FOURTH FLOOR PLAN - NORTH
 SCALE: 1/4" = 1'-0"

CHARLES D. KEEFER, II - CONSULTING ENGINEER Roanoke, Virginia		DATE 1987
RENOVATION & ALTERATIONS TO COULTER BLDG. & NATL BUSINESS COL. JEFFERSON ST. AT FRANKLIN RD., ROANOKE, VA.		SHEET M-4A
MARTIN BROS. CONTRACTORS, INC. ROANOKE, VIRGINIA

DUCTWORK-HVAC

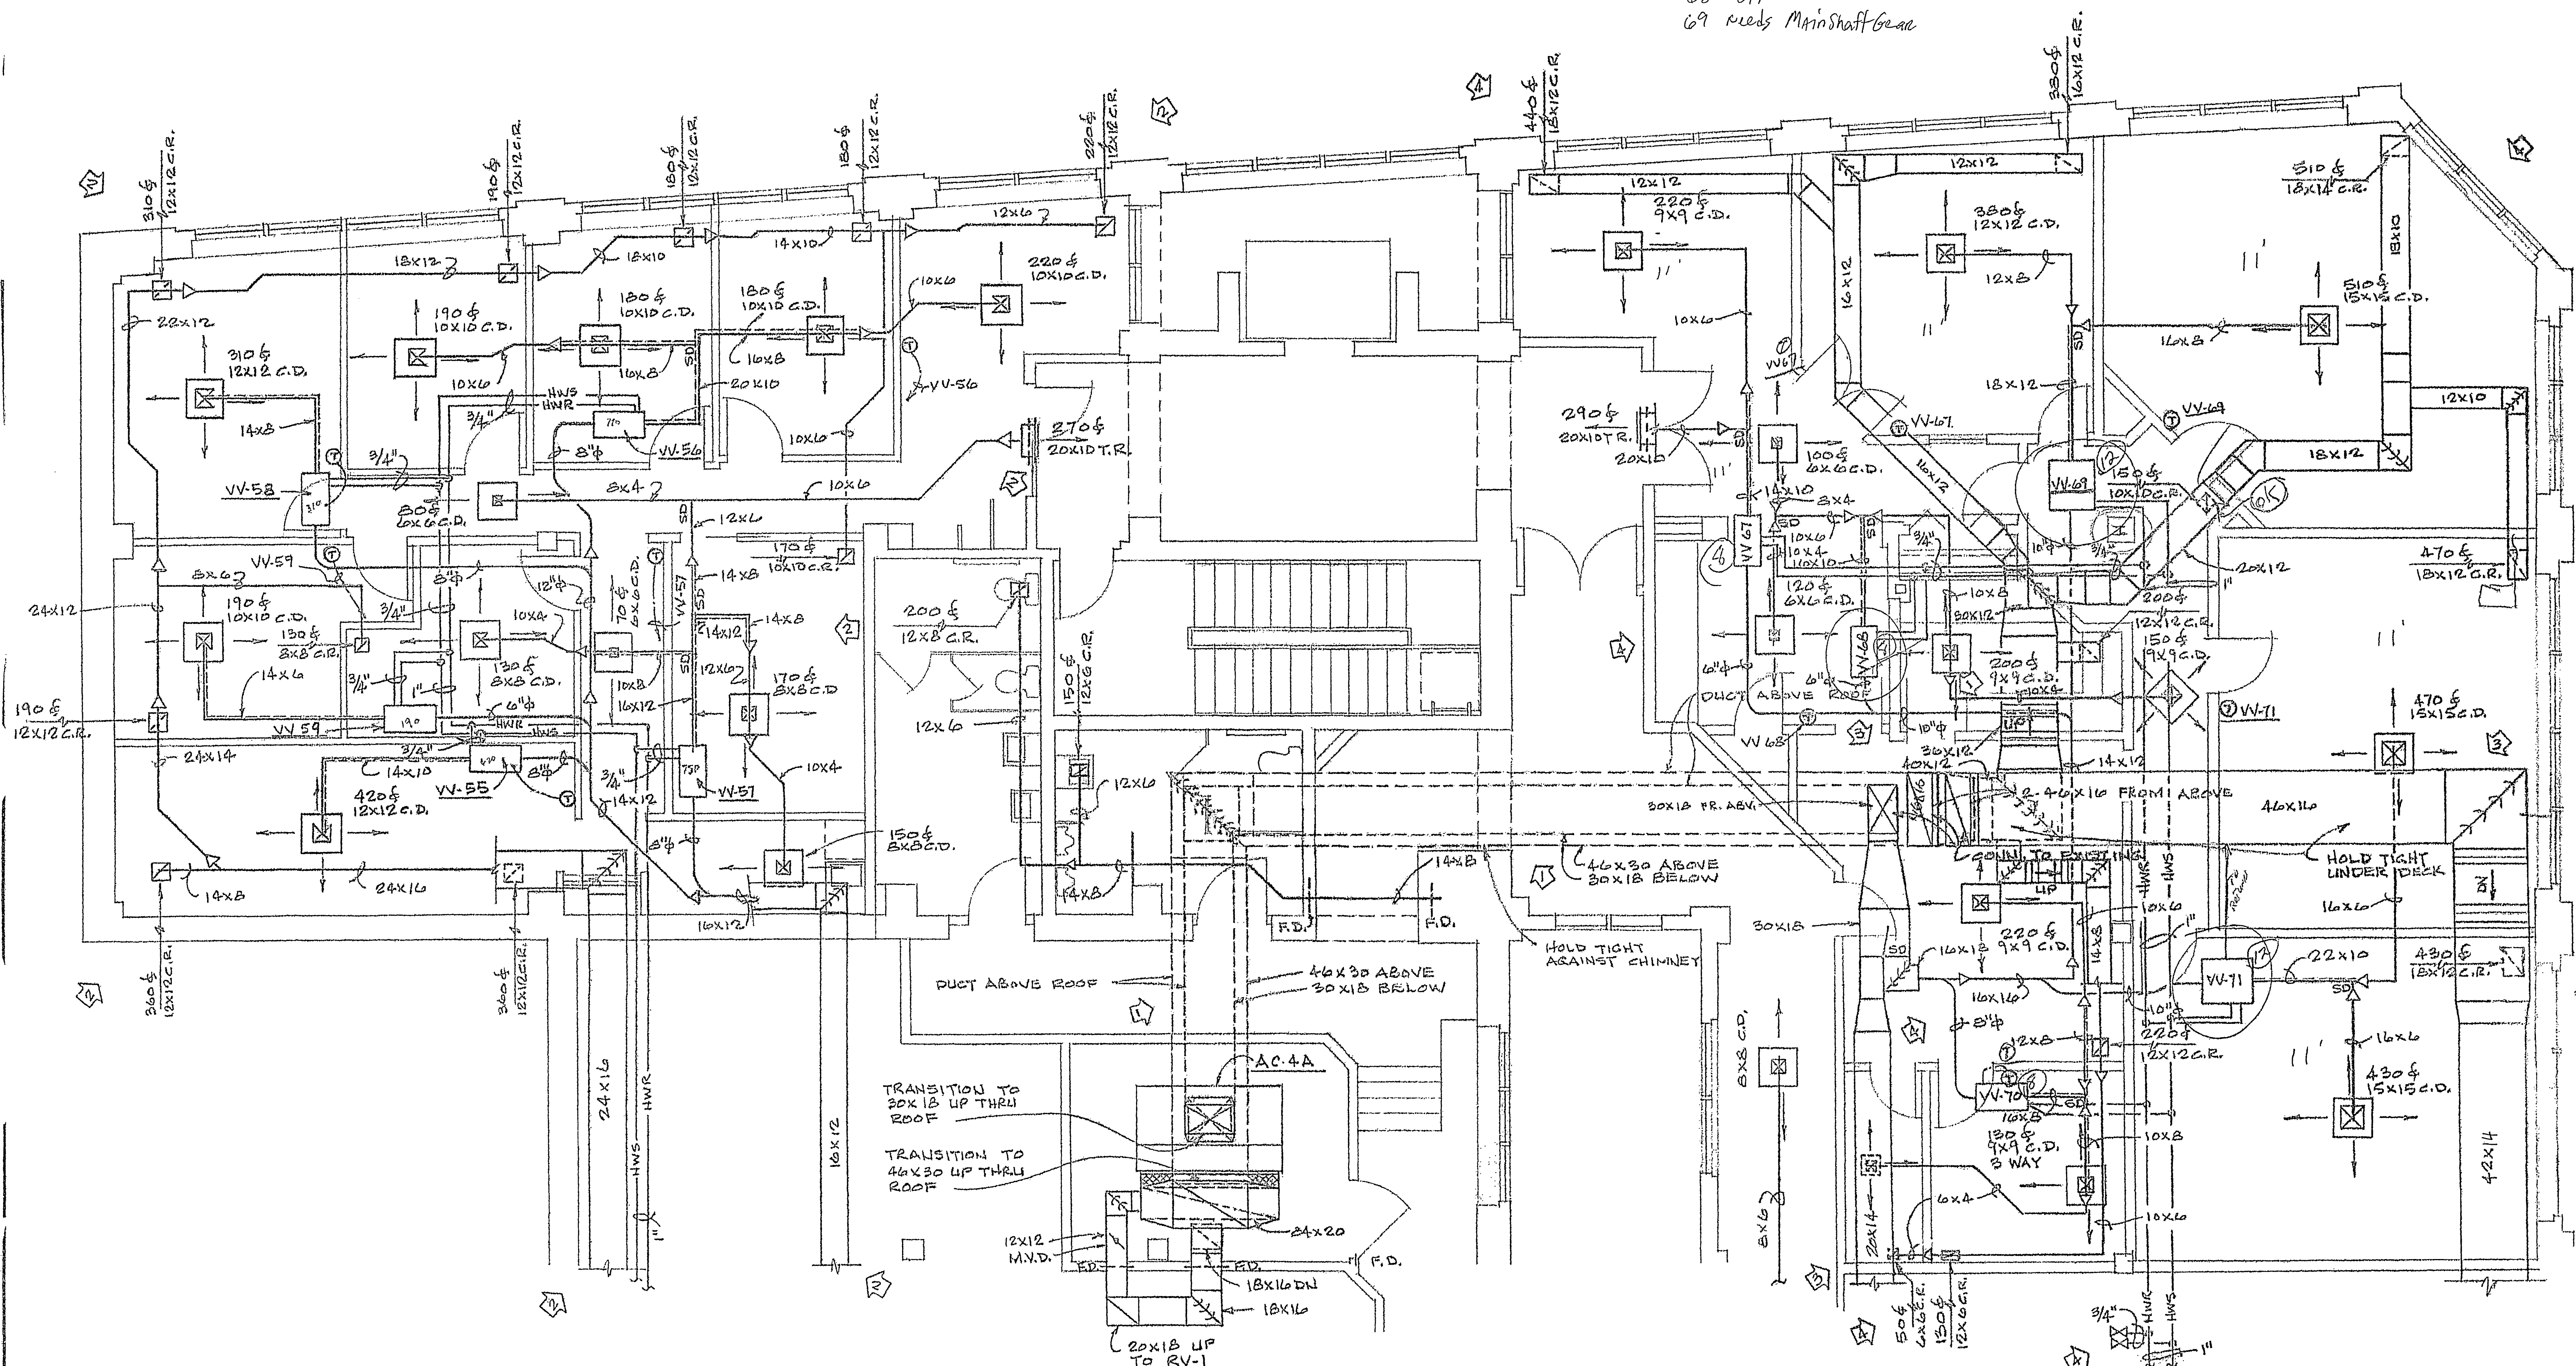
VV-67 Needs B.R.D. box without
 68 OK
 69 Needs Main Shaft Gear
